P23/60534

Re: P23/60534: Application for Permission for development at Westport House & Estate, Westport Demesne, Westport, Co. Mayo for the 'Restoration and Interpretation of Westport Estate', within and around the curtilage of a number of Protected Structures throughout the Estate

Review of the estimated significance of the historic designed landscape of Westport demesne made in the planning documentation submitted to Mayo County Council, case number 2360534, and of the estimated impact of the scheme on that historic designed landscape.

Left: Detail of 1st edition OS map showing the Coach House, possible Ice House, Walled Garden and Lady's island areas. Right: Photo towards existing Coach House complex from NE.

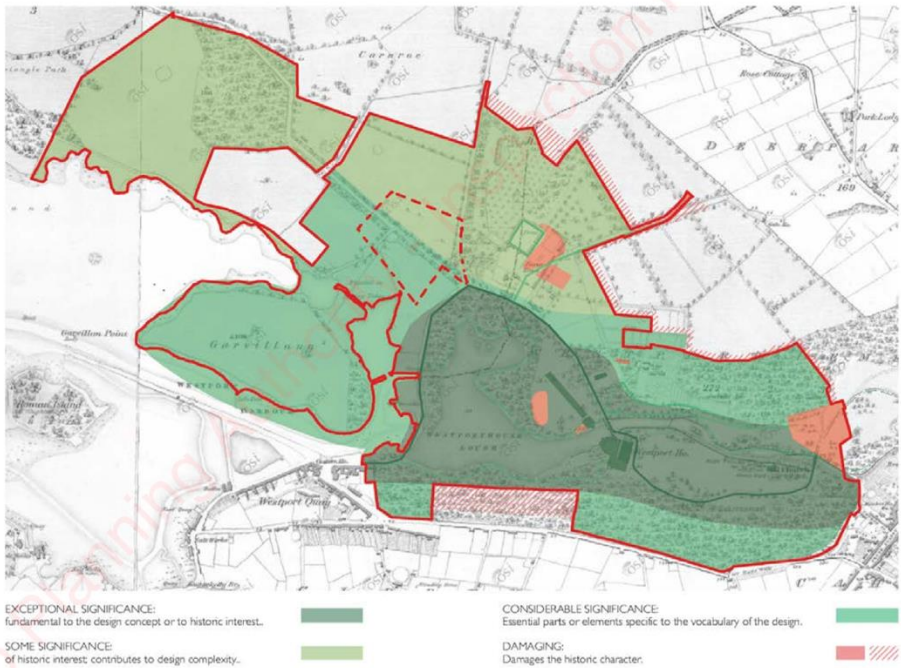
1. The extension of Richard Castle's Coach House, the second most significant building on the demesne, to six times its size- from an existing footprint of 263.4 m² to a total ground floor footprint of 1585 m² in an area of high historic significance (p. 18 of Taylor McCarney Architects, *Proposed Coach House Visitor Centre and Design experience*, Architectural Design Report, Dec. 2023). This is considered to be a substantial over-development of a protected structure, impacting particularly on the setting and character of both the Coach House and the Walled Garden, both significant protected structures.

It will incur the loss of historic landscape in the area east and north of the Coach House which may contain traces of the historic pathways, the ice house indicated on the first edition OS map and other minor structures shown on the maps that do not still stand above ground (see below).

The extension and other interventions are located in an area judged to be of 'exceptional significance' and 'fundamental to the design concept or to historic interest' in the Howley Hayes Conservation Plan (see below).
